Comments to GTB&OICA aiming/levelling proposal (ECE/TRANS/WP.29/GRE/2015/5)

Proposal to improve GRE/2015/5 (GRE-73-18) Poland

73 GRE 14-17 April 2014

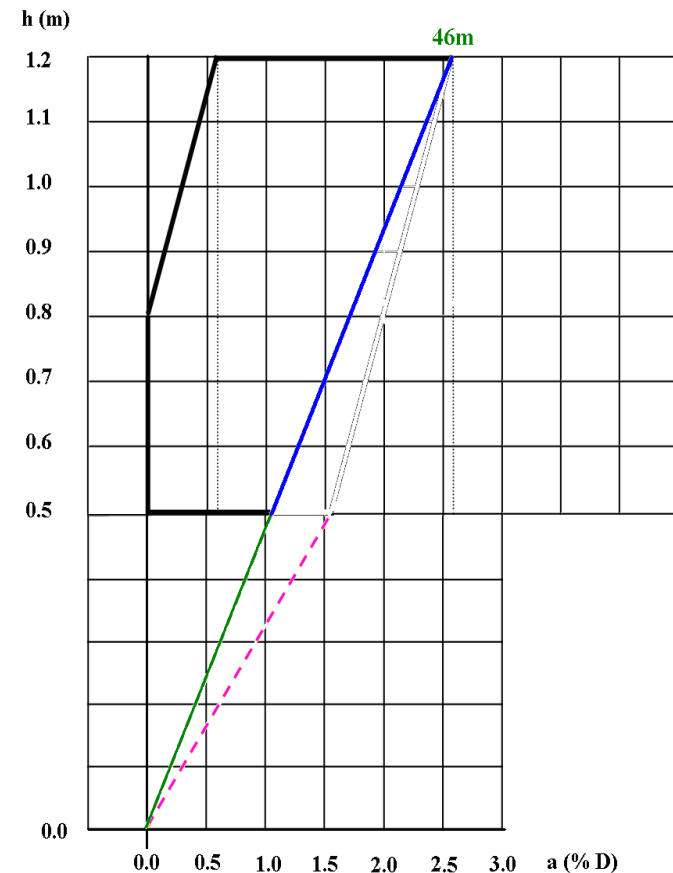
- Adjusting the right side borderline of aiming/levelling tolerance to line described by **road illumination distance** independently on mounting height - straight line crossing 0,0 point of height/aim co-ordinate system.

Present GTB&OICA proposal correspond to range between 31m and 46m and is ambiguous. Poland suggest it should be at least 50m but we are open for other opinion.

Aiming/ levelling tollerances

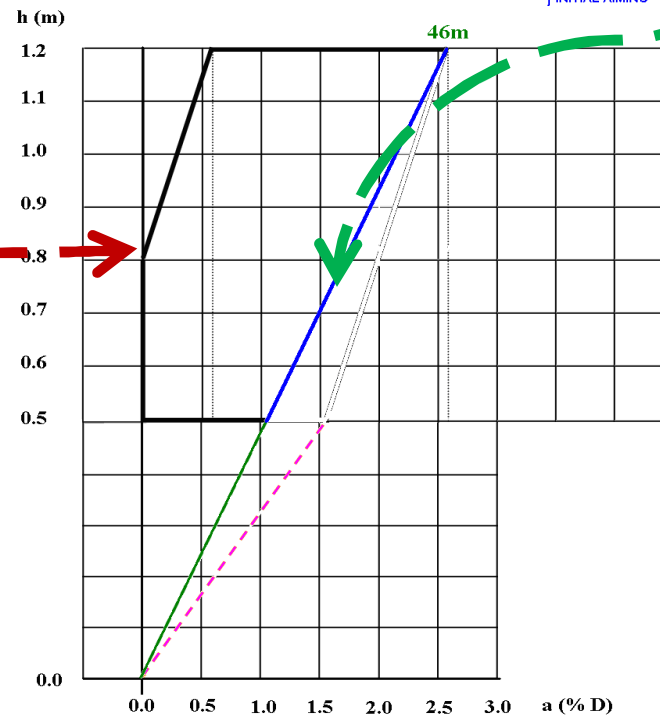
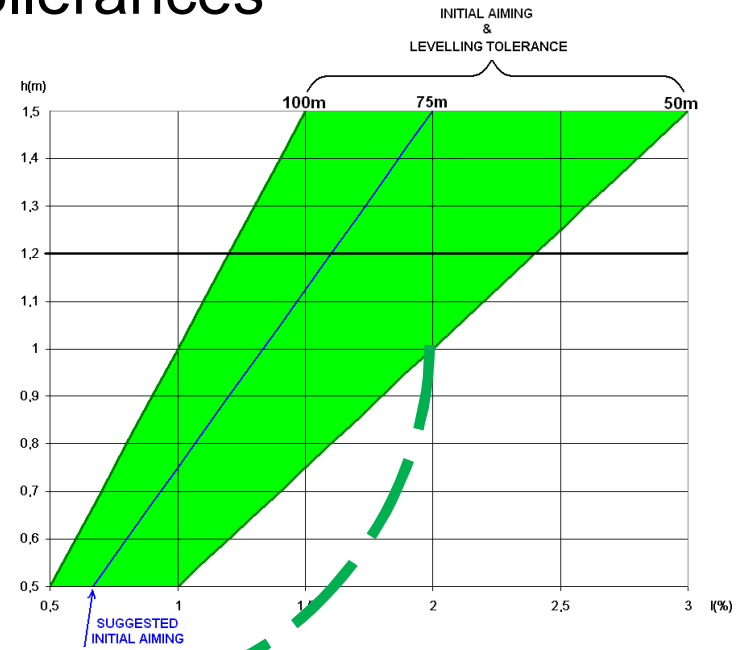
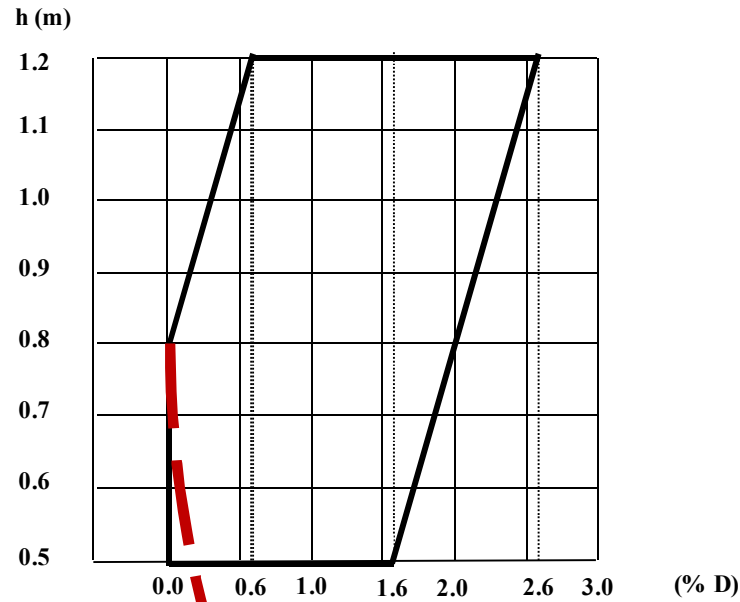
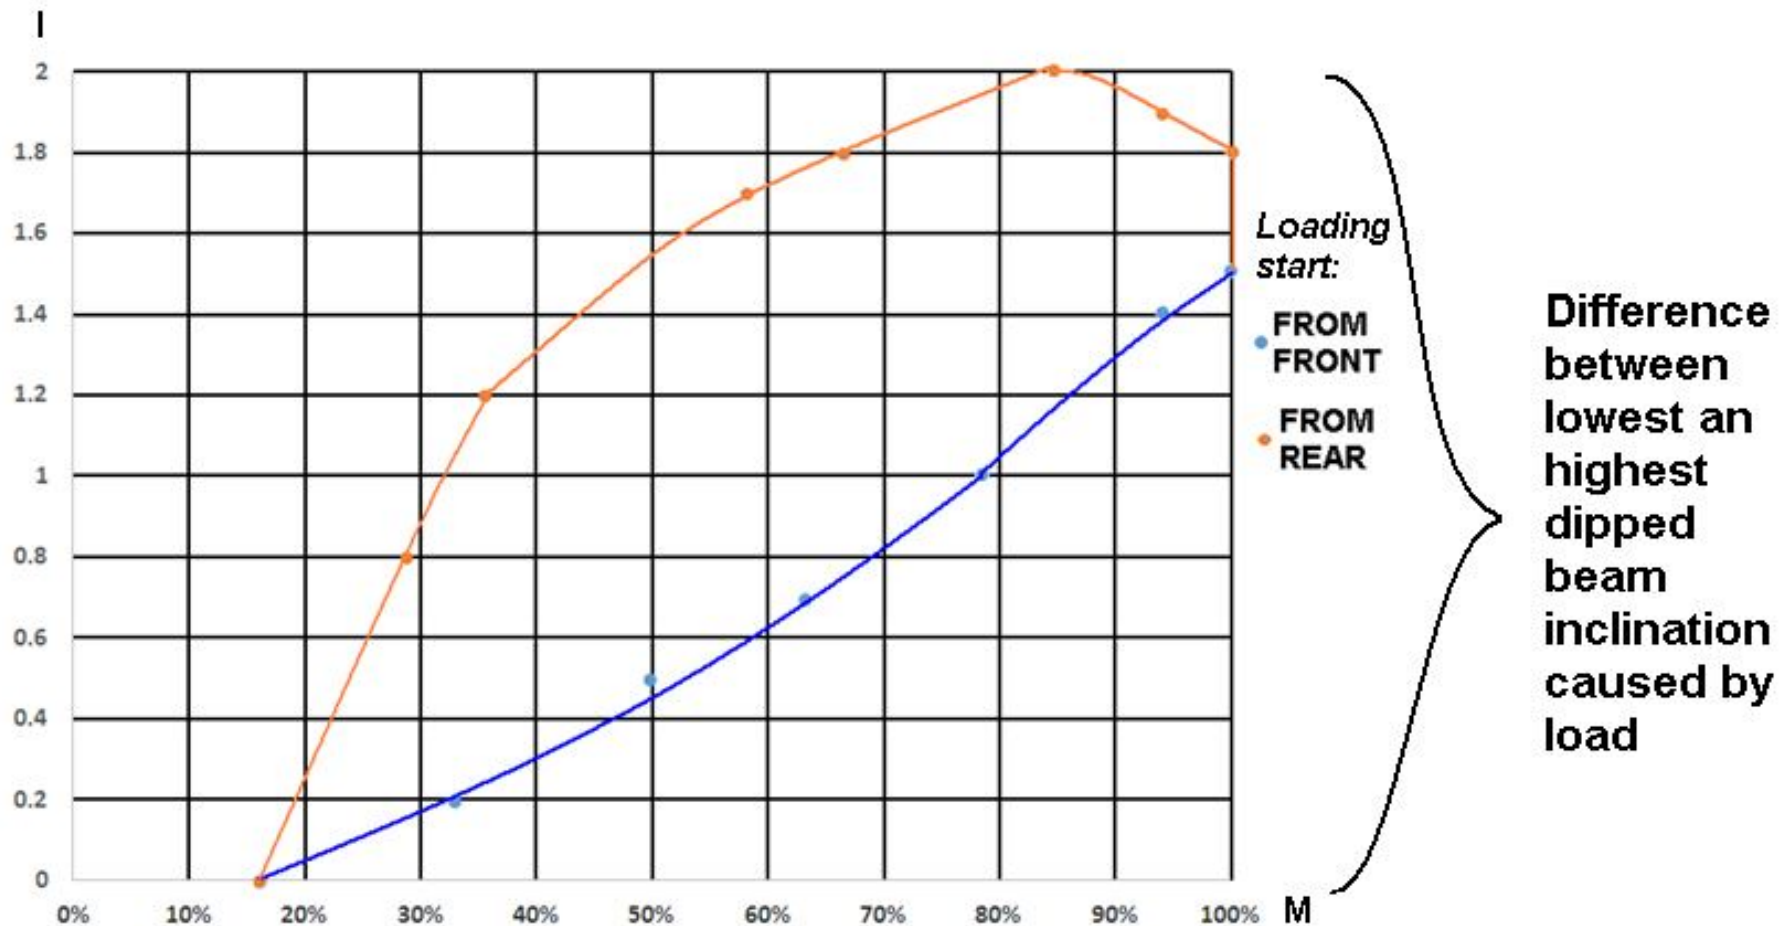
**Instead
GTB&OICA 50% LOADING THRESHOLD
take into account
REAL VEHICLE PITCH CHANGE WITH LOADING**

•Replace the artificial and ambiguous 50% load criterion by **difference between maximum and minimum pitch** caused by load change in **whole range of possible load distributions**. It is universal criterion for all kind of vehicles not only for cars

- 1) Vehicles meeting range of tolerances do not need any levelling device.
- 2) Vehicles which are inside doubled tolerance range can use manual or automating levelling.
- 3) Vehicles exceeding doubled tolerances range shall use automatic levelling only.
